ADDENDUM NO. 1

March 19, 2025

School District of Haverford Township | Coopertown Elementary School Renovations & Additions
CRA Project No. 3758

A3.3

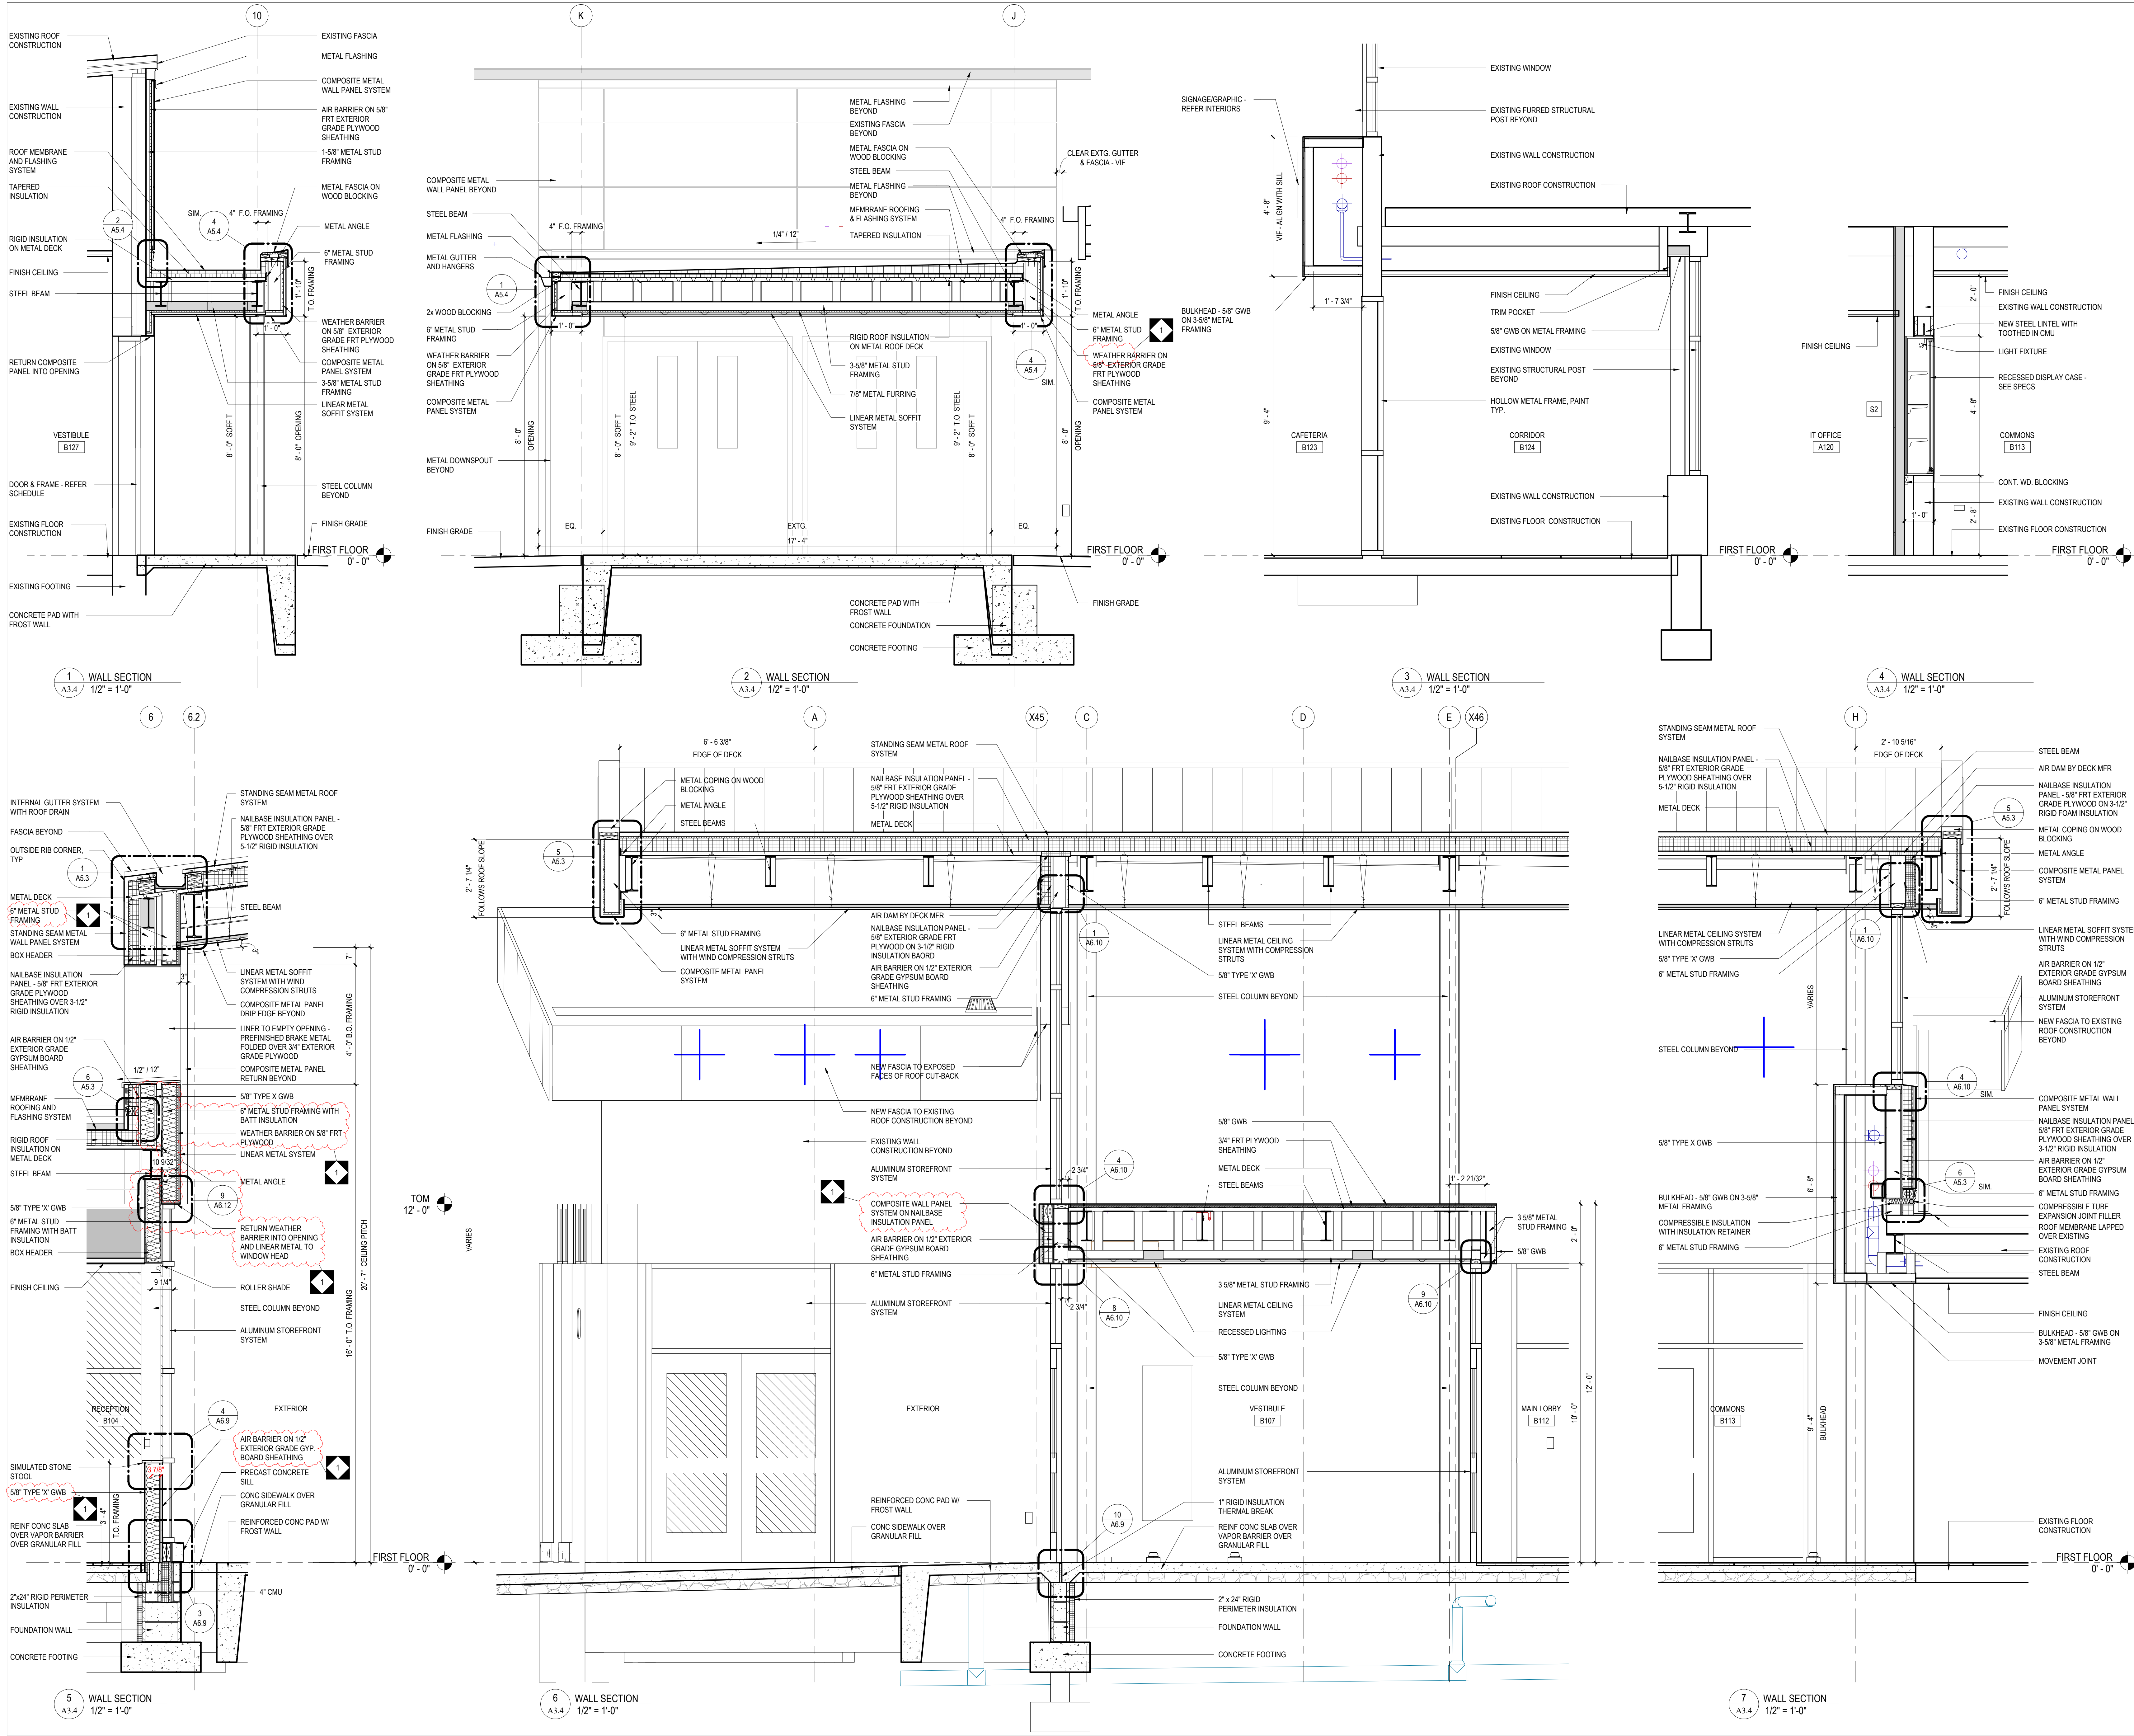
1. 1/A3.3
 - a. Expansion joint location updated to be against structure
2. REVISE - Annotation inconsistencies clarified throughout

5 WALL SECTION
A3.6 1/2" = 1'-0"

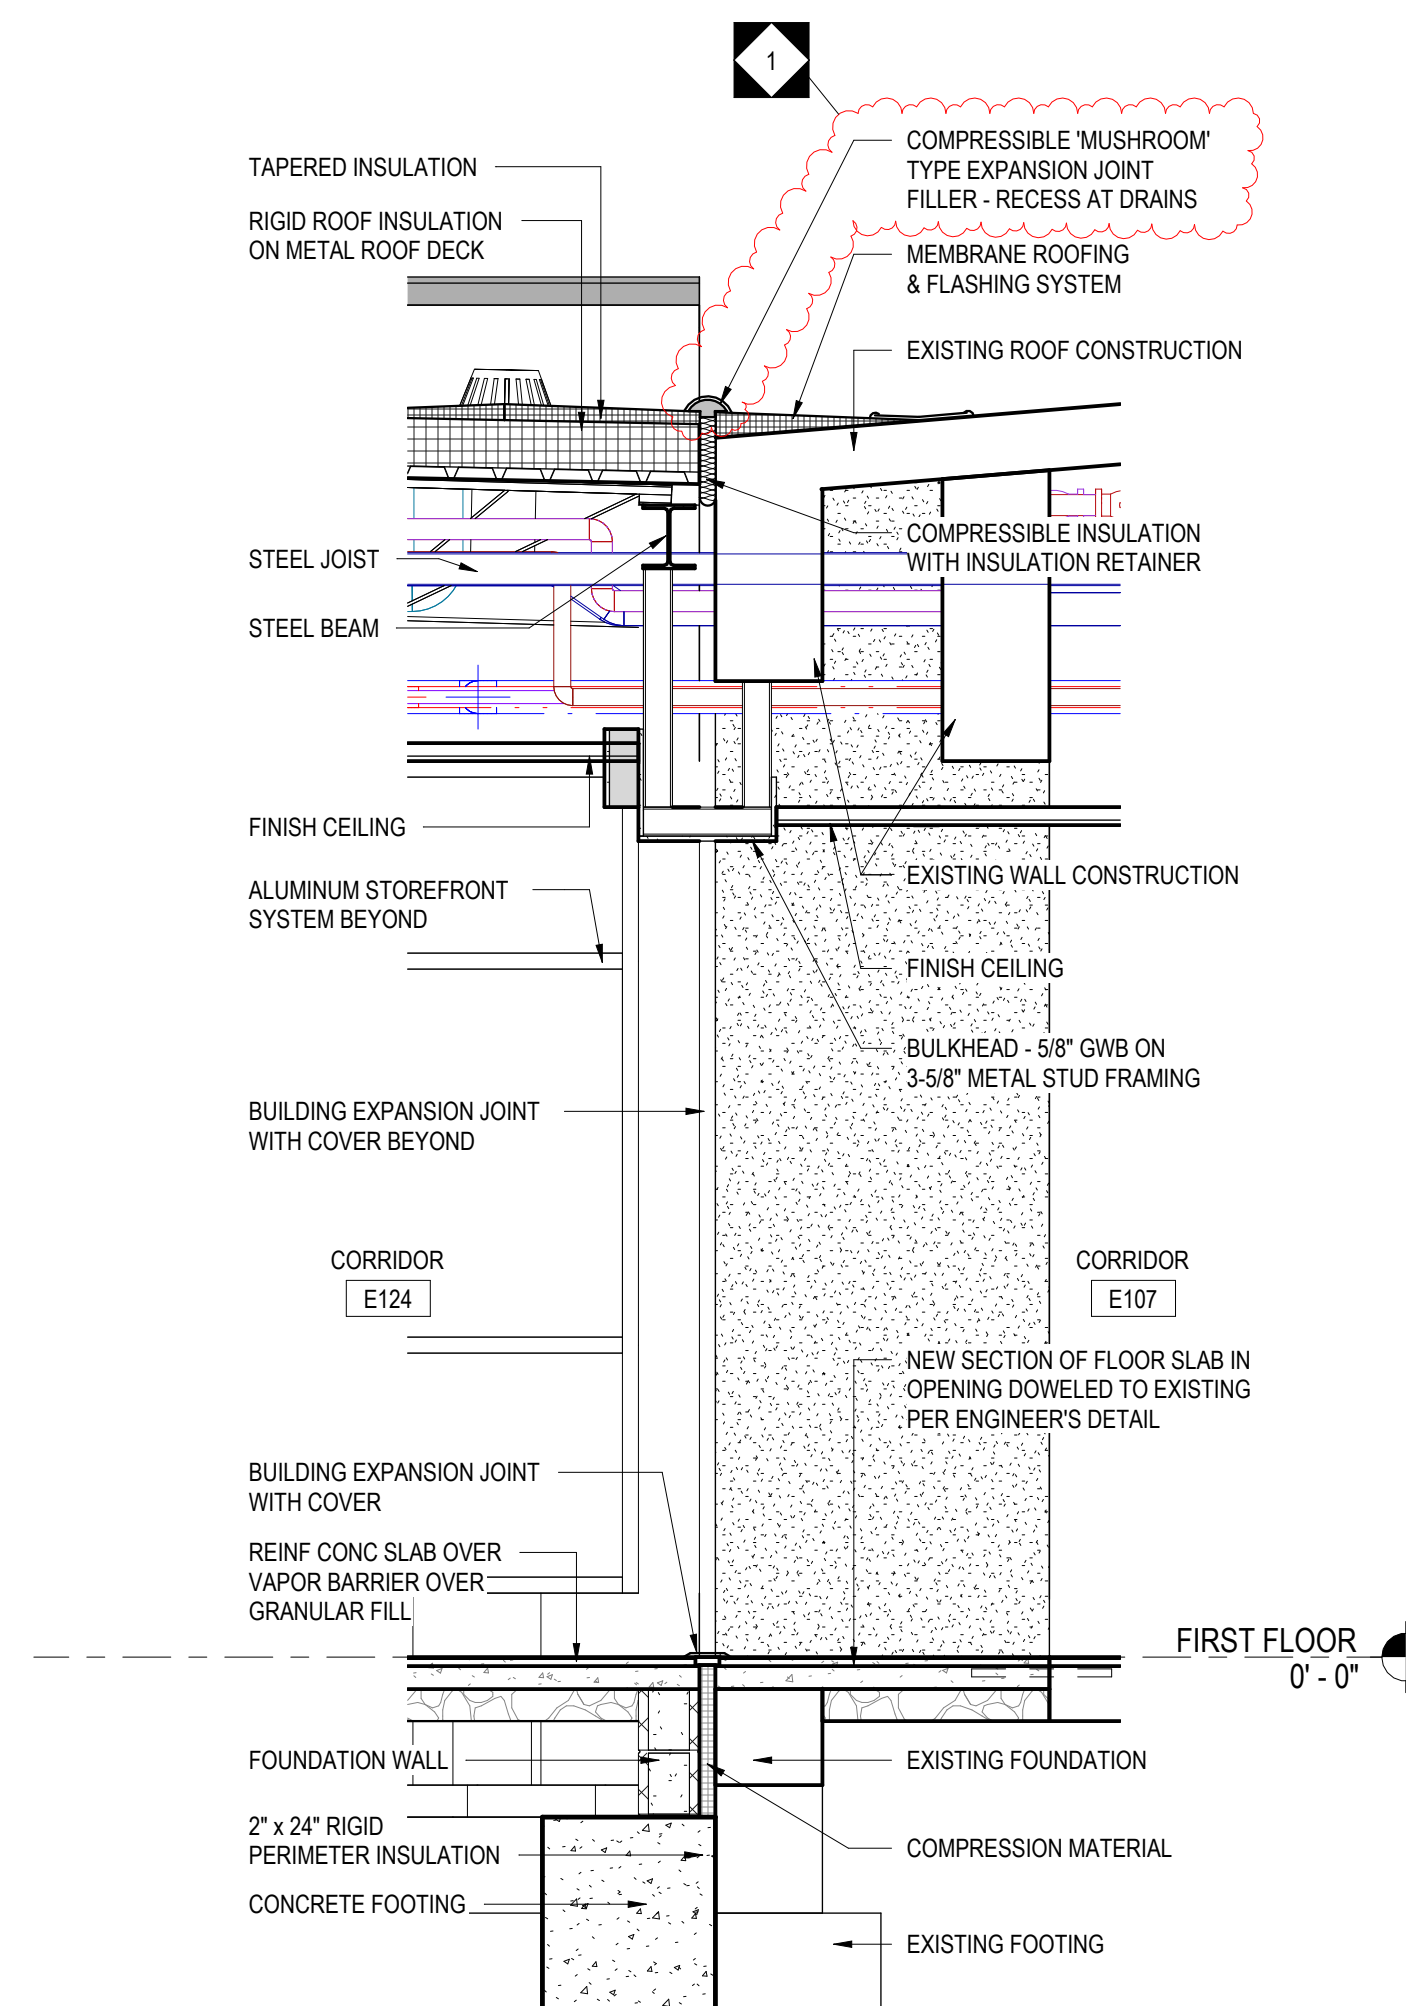
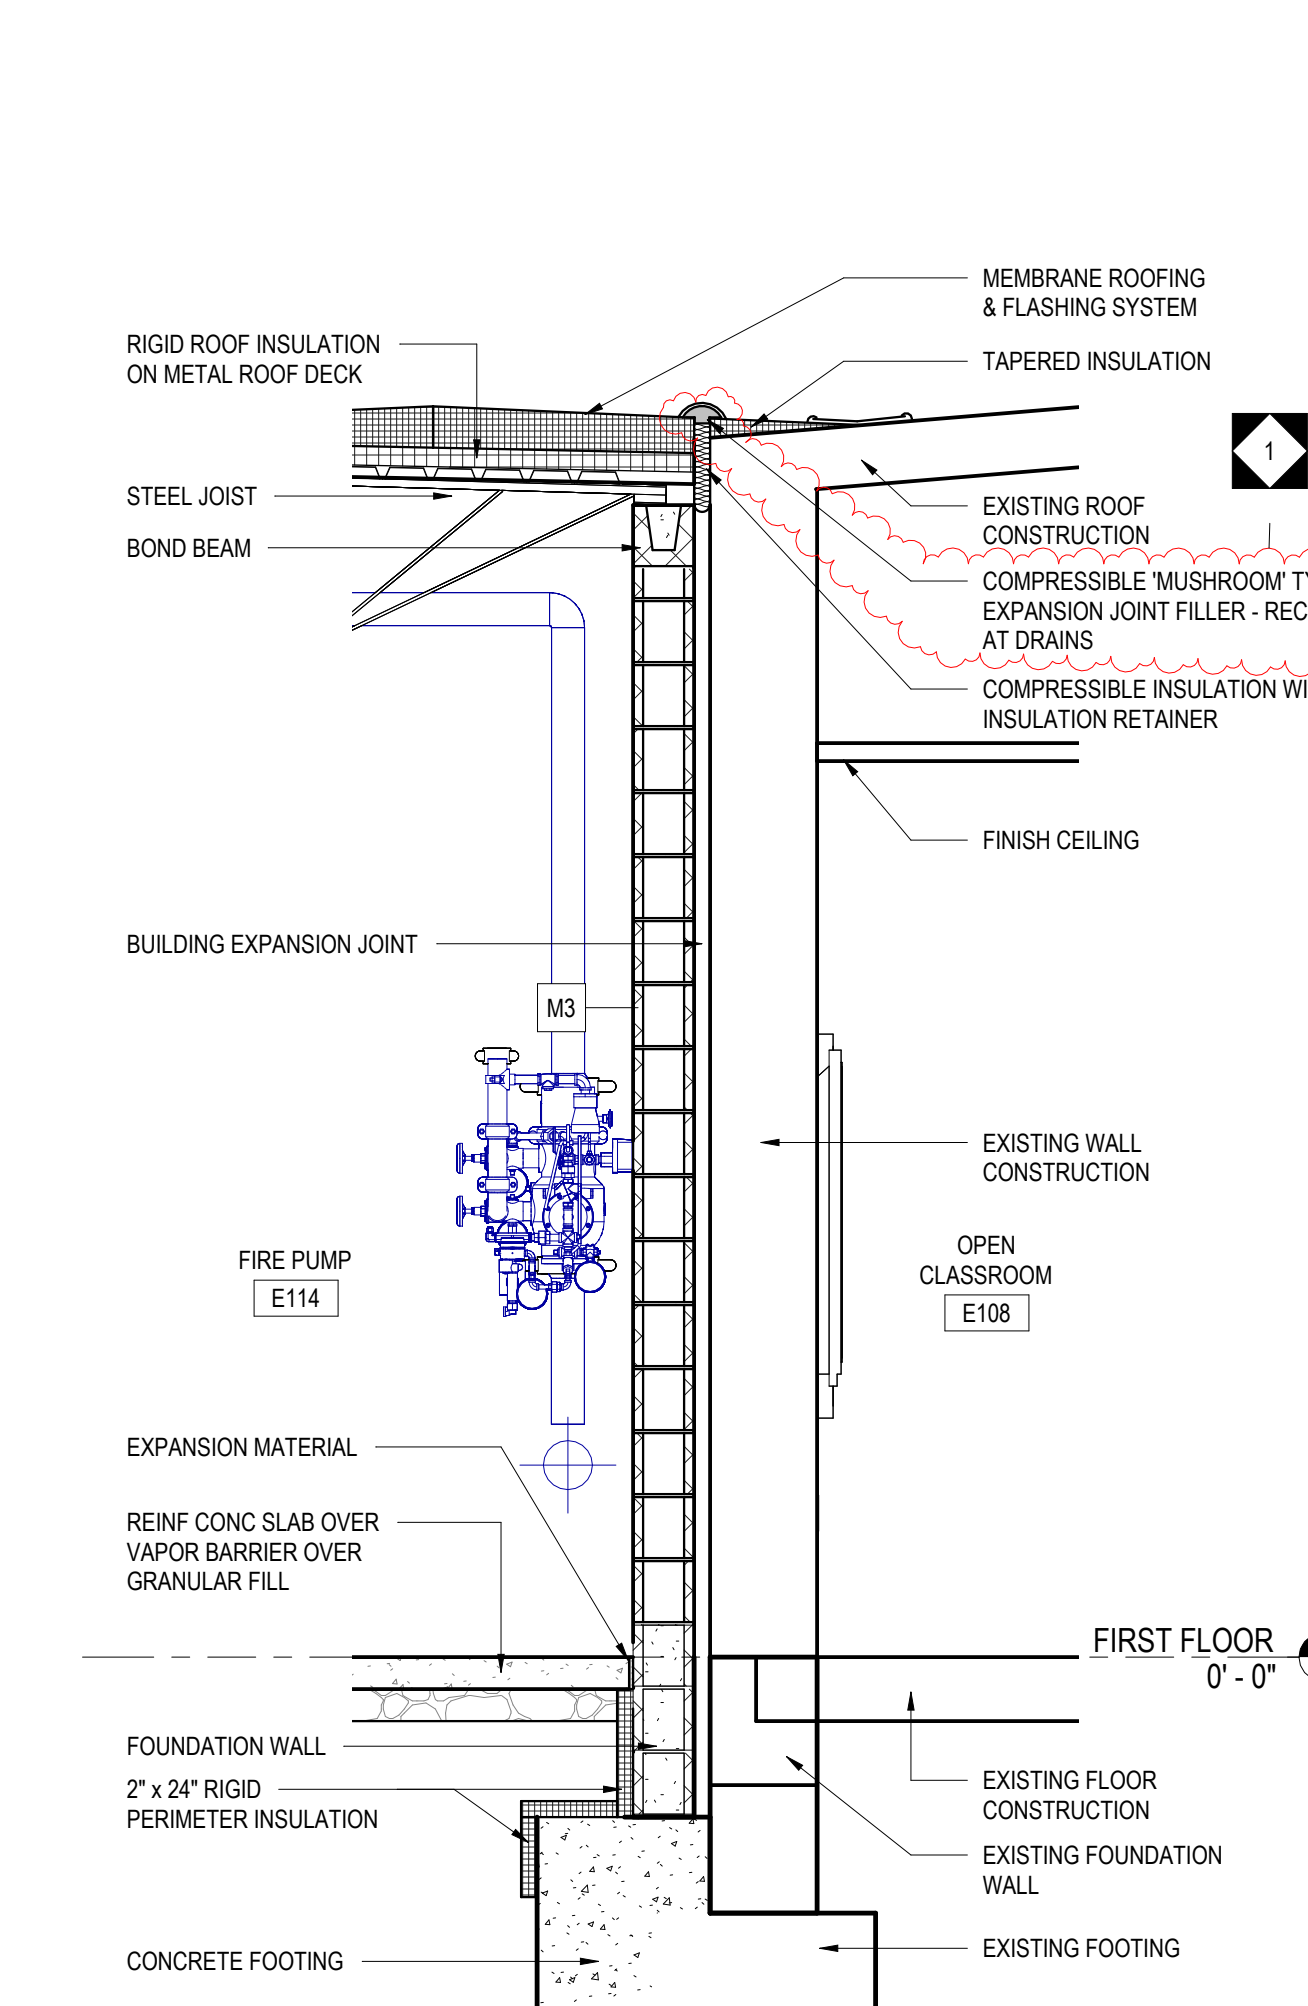
1. REVISE - Annotation inconsistencies clarified throughout
2. 5/A3.6 & 6/A3.6
 - a. REVISE - Expansion joint filler changed from tube type to mushroom type
